Access Compliance Report

Public Rights-of-Way

(Curb Ramps)

Intersection ID: 3737	Main Street: CANTER_POST_DR	Cross Street: TROTTER_RD	Location:	E
ADA ID: C6100E67C0F9	Ramp Type: Perp	Initial Pass/Fail: Fail	Overall Compliance: No	Severity Score: 12.5
Codes/Mitigation Info/Possible Solution		Field Measurements/Component Compliance

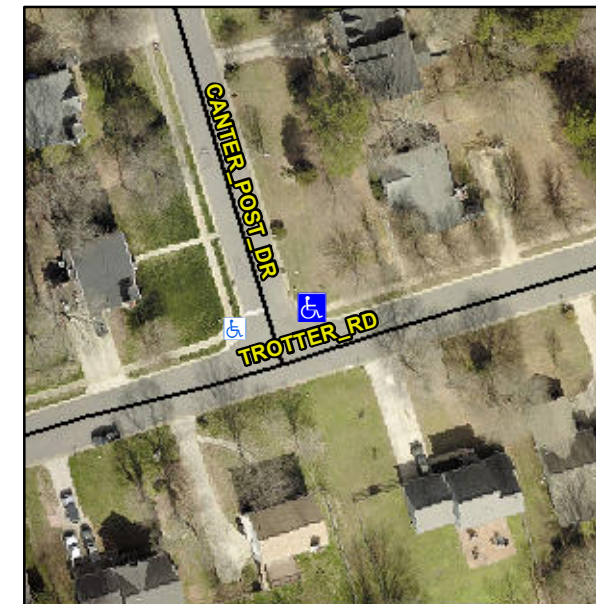
Not Found, R304.2.2

Compliance	Description	Data	Compliance	Description	Data
N/A	Ramp Length (in)	28.0	No	Ramp Slope (%)	8.8
Yes	Ramp Width (in)	48.0	Yes	Ramp XSlope (%)	1.6
N/A	Flare Type LT	N/A	N/A	Flare Type RT	N/A
N/A	Flare Slope LT (%)	N/A	N/A	Flare Slope RT (%)	N/A
N/A	Flare Traversable LT?	N/A	N/A	Flare Traversable RT?	N/A
N/A	Landing Length (in)	N/A	N/A	DWS Provided?	N/A
N/A	Landing Width (in)	N/A	N/A	DWS Contrast?	N/A
N/A	Landing Slope (%)	N/A	N/A	DWS Length (in)	N/A
N/A	Landing X Slope (%)	N/A	N/A	DWS Full Width?	N/A
N/A	Landing Curb? (Y/N)	N/A	N/A	DWS Offset (in)	N/A
N/A	Shared Landing?	N/A			
N/A	Gutter Ponding?	N/A	N/A	Gutter Slope (%)	N/A
N/A	Gutter Lip Ht (in)	N/A	N/A	Gutter X Slope (%)	N/A
N/A	Painted X Walk1?	No	N/A	Painted X Walk2?	N/A
	X Walk 1 Direction	To W		X Walk 2 Direction	N/A
N/A	X Walk 1 Width (in)	N/A	N/A	X Walk 2 Width (in)	N/A
	X Walk 1 Slope (%)	4.5		X Walk 2 Slope (%)	N/A
	X Walk 1 X Slope (%)	0.1		X Walk 2 X Slope (%)	N/A

Remove & Replace Entire Ramp.
